Ref: PS3173

13th June 2024

RE: (PLANNING REF. 2024/1364/P) NCP SAFFRON HILL, 14 ST CROSS STREET, LONDON EC1N 8UN – DAYLIGHT, SUNLIGHT AND OVERSHADOWING

Example window view of W9, Floor 5, Flat 5.5 taken from DPR Report, Appendix 4

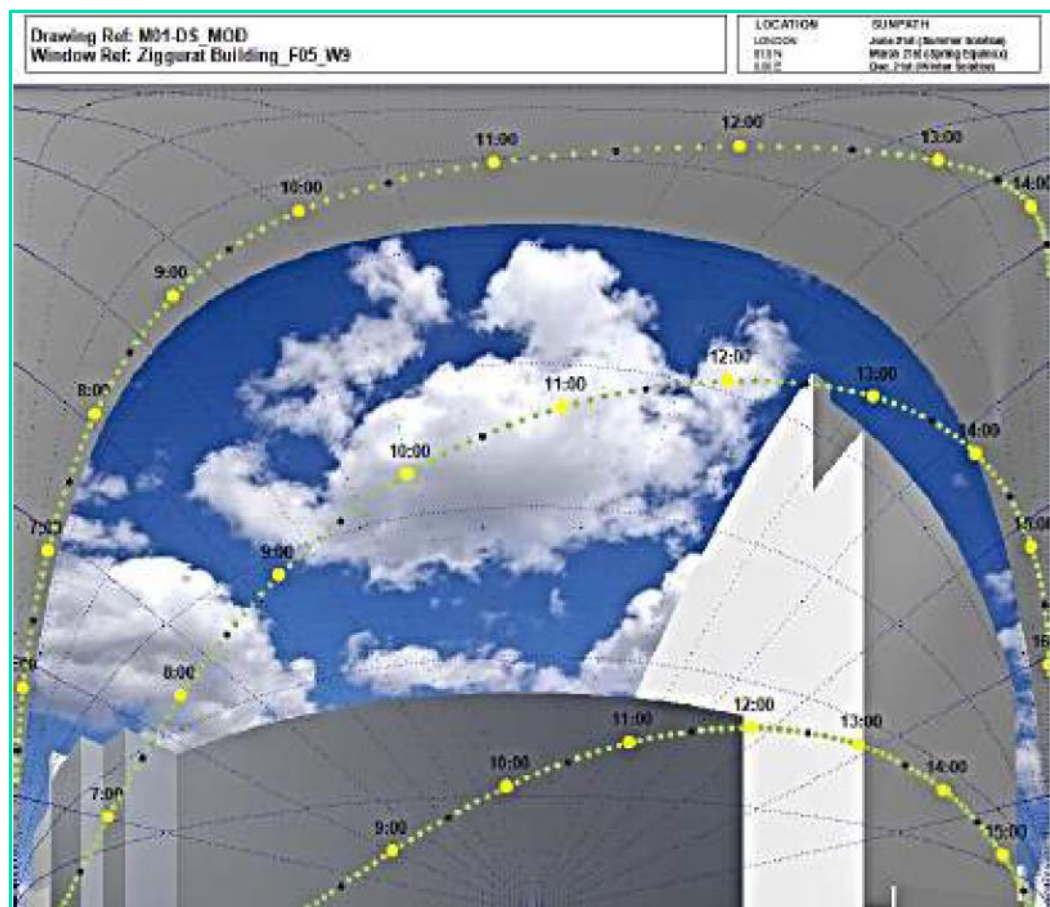
1. 17 of the 72 window views show no impact on the sunpath at all during the course of the year – these are windows located on the lower levels of the Ziggurat Building.
2. A further 21 of the window views indicate no impact on sun on 21 March or 21 December (or the months in between) and only fractional reductions close to the 21 June.
3. A further 22 window views, all taken from flats on the upper levels, clearly illustrate the limiting effect of the overhanging projections above the window; an inherent design feature of the Ziggurat Building, which blocks out the top part of the sky dome. In many cases this blocks out the sun path completely on 21 June – see below example of a window at 5th floor level within Flat 5.5:

In the above example, the window receives no sunlight on 21 March because of the existing building obstructions opposite, and no sunlight on 21 June due its own overhanging projection above the window. Given the very tight nature of Saffron Street and the close proximity to the Site, this makes this particular flat inevitably more susceptible to sunlight reductions during the middle part of the year – and it is clear that even a modest form of extension to the existing NCP car park would result in a loss of sunlight.
